ORIGINATION FORM •

Proposed Revisions to a Standard Plans Index

Index Number: 641-020 Sheet Number (s): All Index Title: Concrete CCTV Pole

INDEX	SHEET
641-020	1 of 5

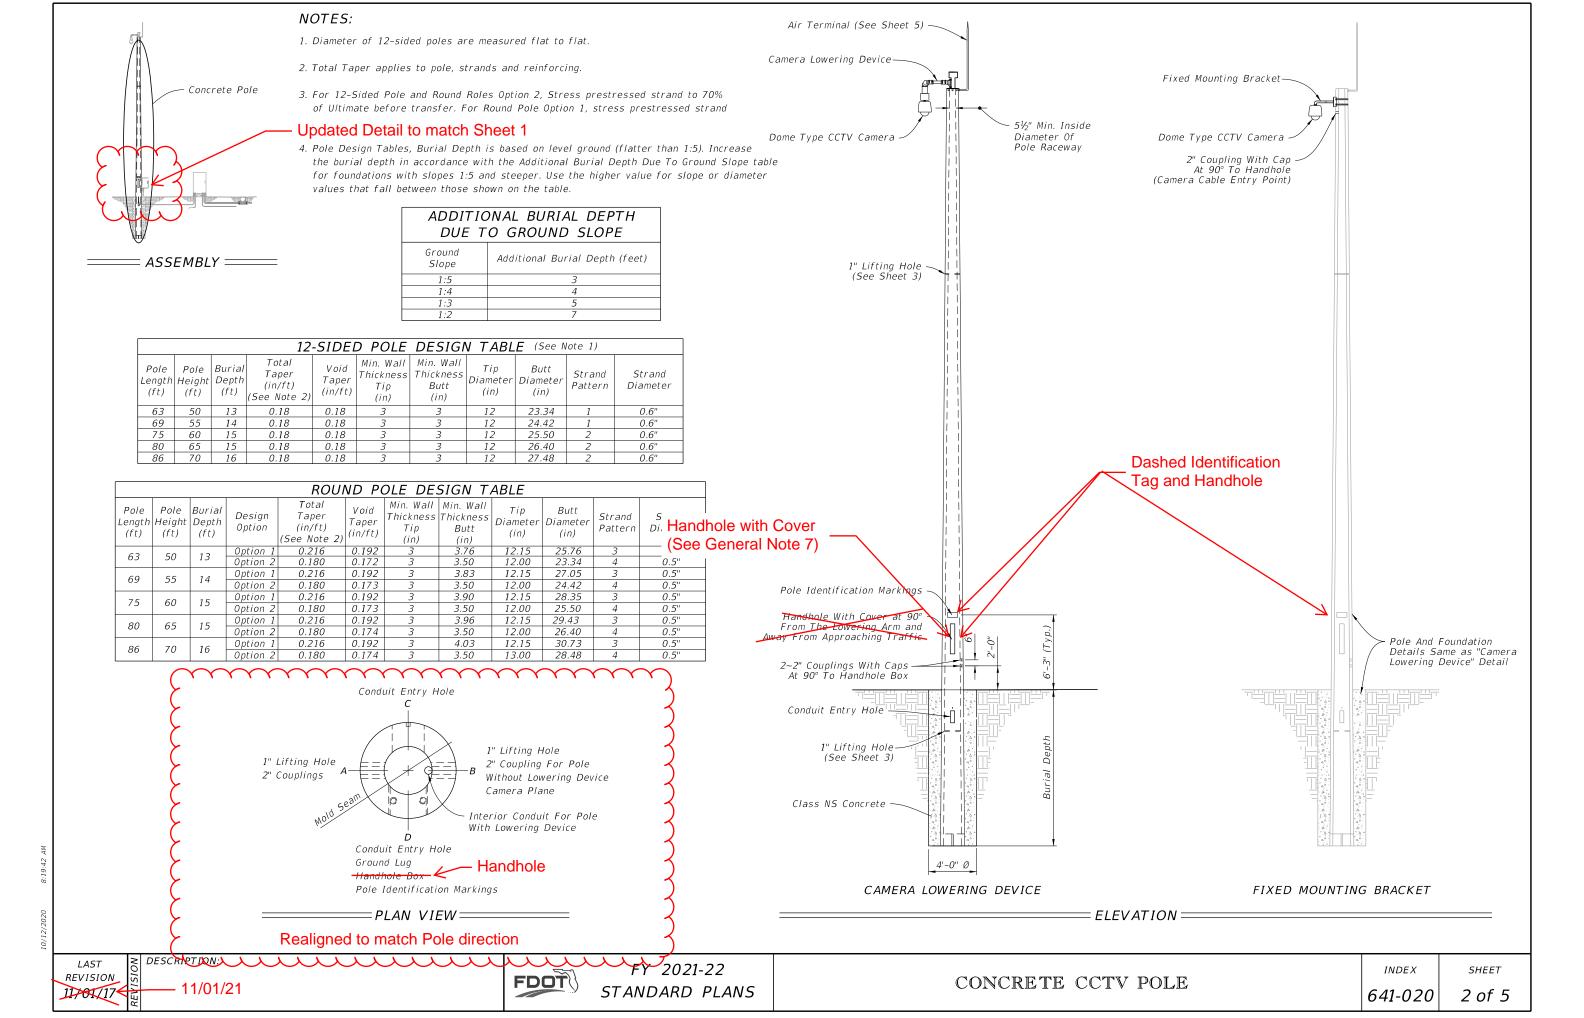
Sheet 1: Move Note 3 to new Note 7; Added Note 7; Renumbered General Notes; Dashed the Identification Tag and the handhole in the CCTV POLE ASSEMBLY detail.

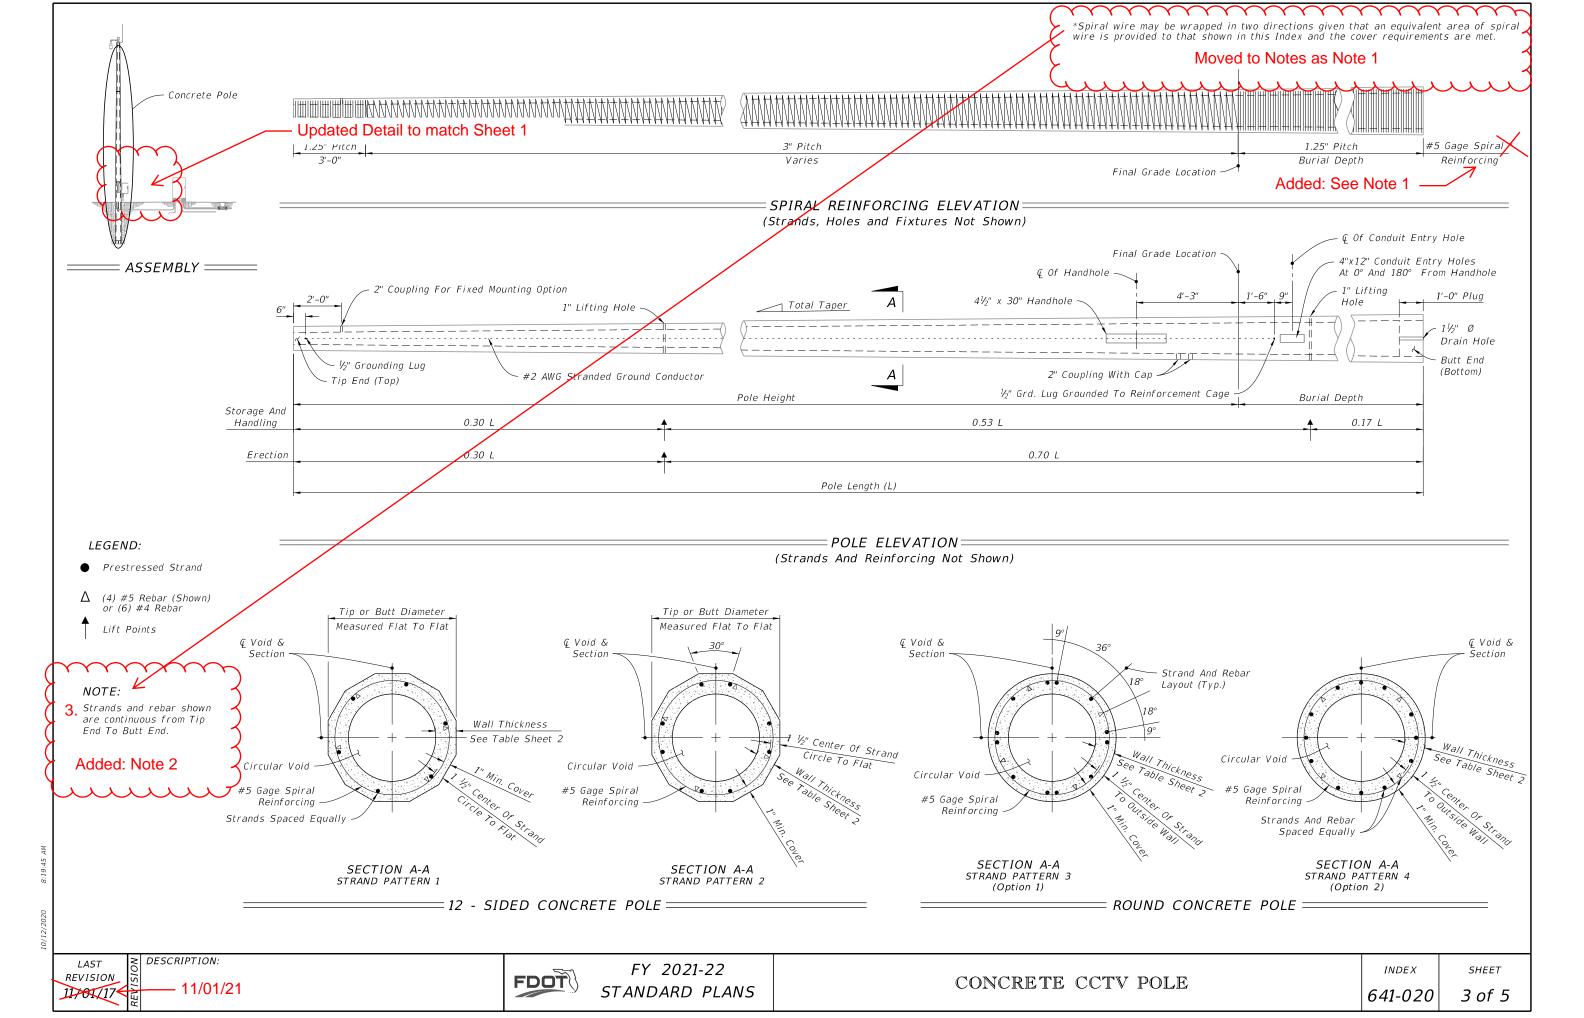
Sheet 2: Updated the Assembly detail to match Sheet 1; Realigned the PLAN VIEW detail to match the Pole direction;

Dashed the Identification Tag and the Handhole in the ELEVATION detail.

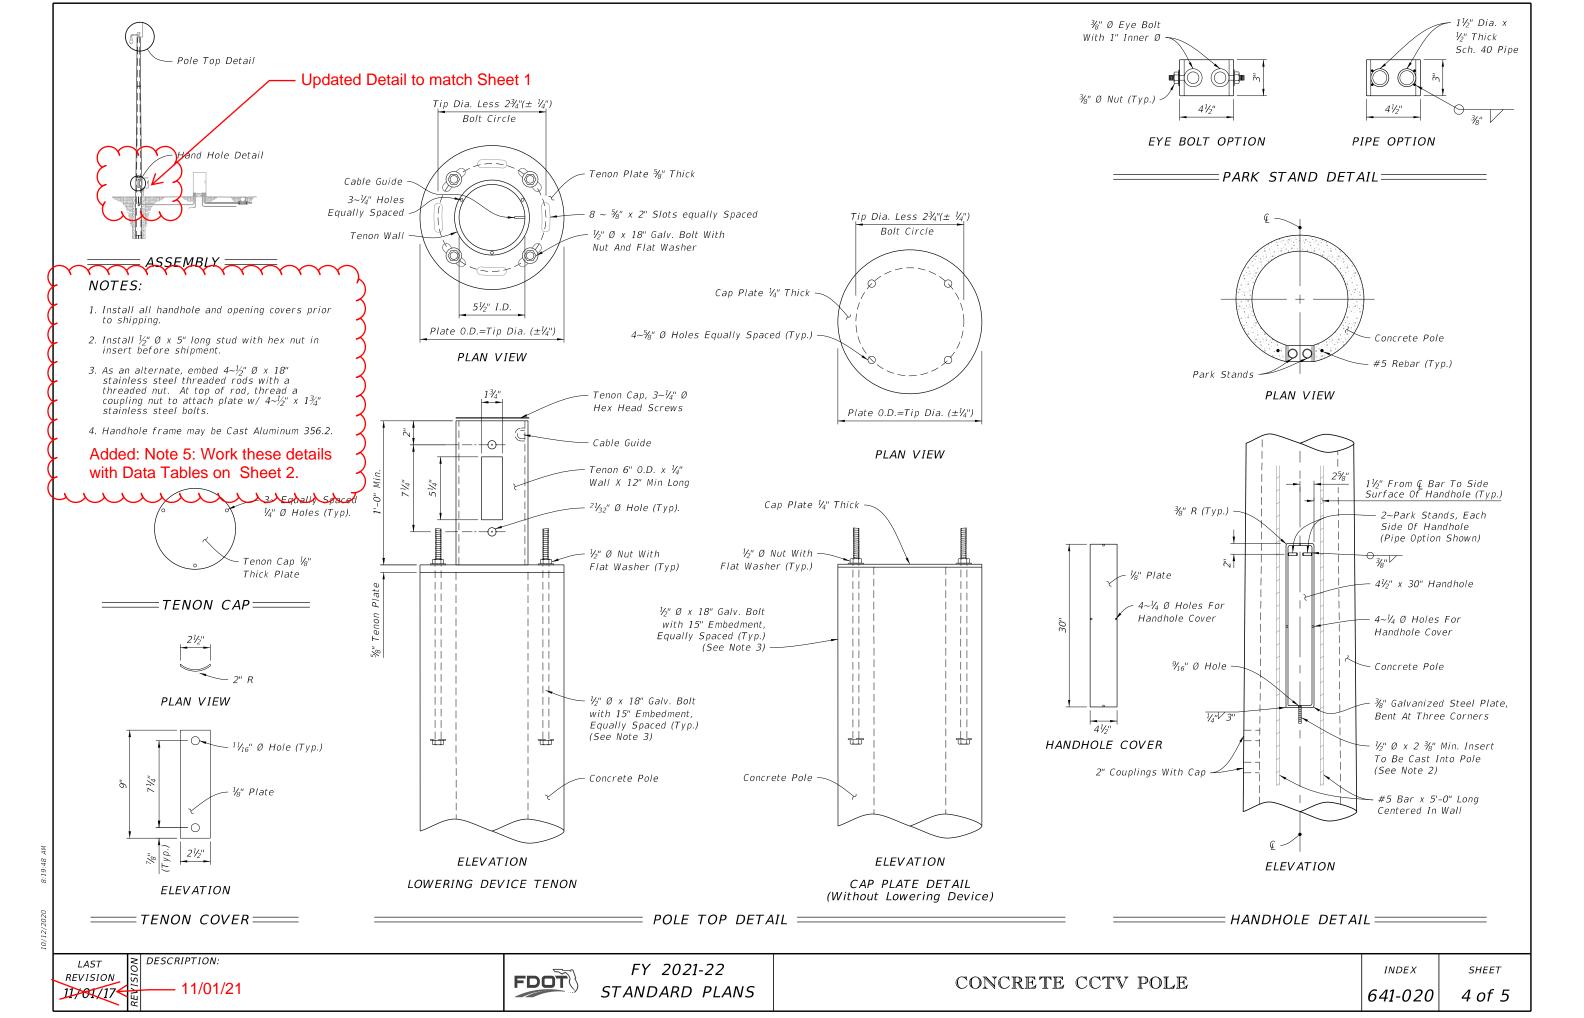
Sheet 3: Updated the Assembly detail to match Sheet 1; Moved the Spiral wire note in the SPIRAL REINFORCING ELEVATION detail to the Notes and added See Note 1 to the Spiral Reinforcing call out; Dashed the Conduit Entry Holes in the POLE ELEVATION detail to be consent with the Pole's view.

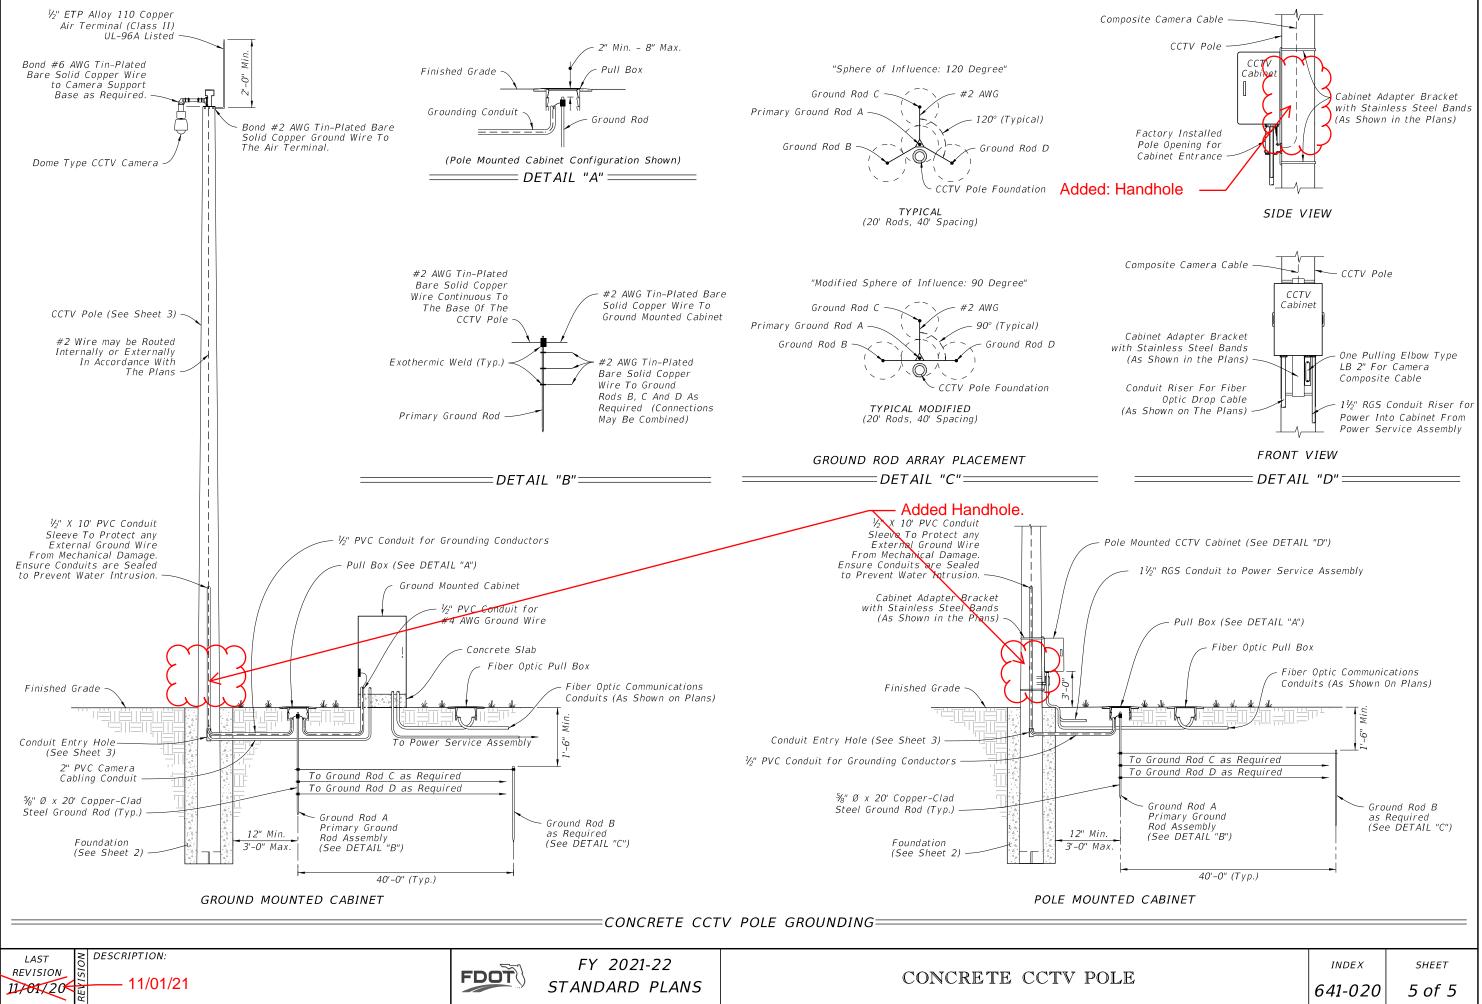
Sheet 4: Updated the Assembly detail to match Sheet 1; Added Note 5.

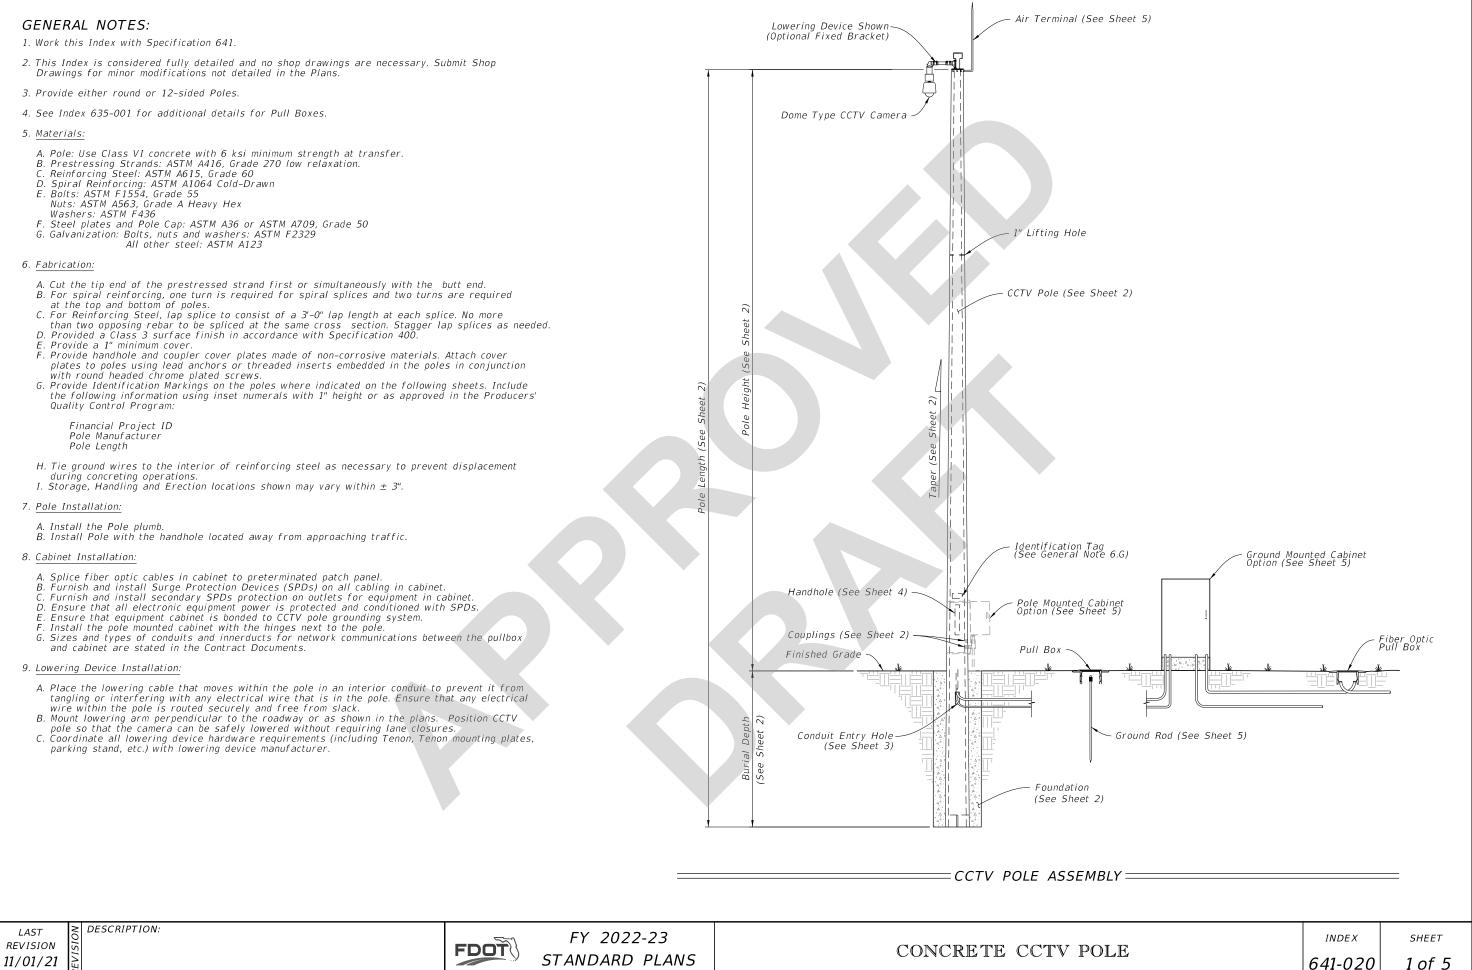
Sheet 5: Added Handhole to the CONCRETE CCTV POLE GROUNDING detail and to DETAIL "D"-SIDE VIEW detail.
